Pocketbook International SA.

Ref: FCC Class II Permissive change for FCC ID: 2AUVWPB629

This is to request a Class II Permissive change for FCC ID: 2AUVWPB629 originally granted on 08/17/2023 (date).

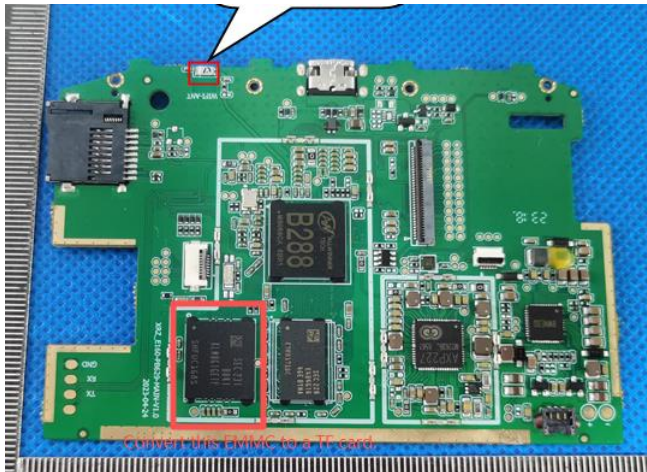
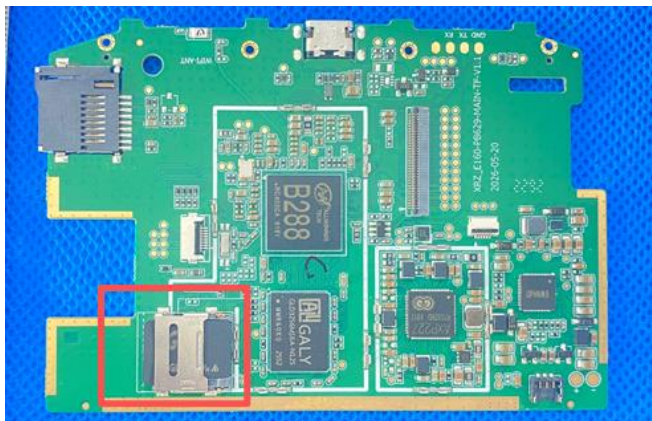
1. TF card version, related circuit has changed.

Ref Des	V1.0 (Old)	V1.1 (New)	Change Type
R198	2.7pF, populated	NC	Removed
C181	Capacitor, populated	NC	Removed
R55/R62/R63/R64/R88	None, direct connection	33 Ω	Added
R11	43K-1%	36K-1%	Modified
R203	1M-1%	750K-1%	Modified
R202	52.3K-1%	NC	Removed
R207	1M-1%	210K-1%	Modified
R204	47.5K-1%	10K-1%	Modified
L7	2.2uH	4.7uH	Modified
C113	102/50V	473/50V	Modified
C109	103/50V	473/50V	Modified
C39	475	104	Modified
C110, C114	104/50V	105/50V	Modified
J2	C1200RS10314G0205RA	TCR16-221602-F1	Part No. Changed
R141	Populated	NC	Removed
R20	Populated	NC	Removed
U2	Populated	NC	Removed
R14	Populated	NC	Removed
C47	Populated	NC	Removed
R29	Populated	NC	Removed
R56	5.6K-1%	4.7K-1%	Modified
C90, C111, C112	Original	0805, X7R	Package & Material Modified
C124	Original	0603-106	Package Parameter Modified
R31	None	1K	Added
TP4	Undefined	2mm	Structural Modified
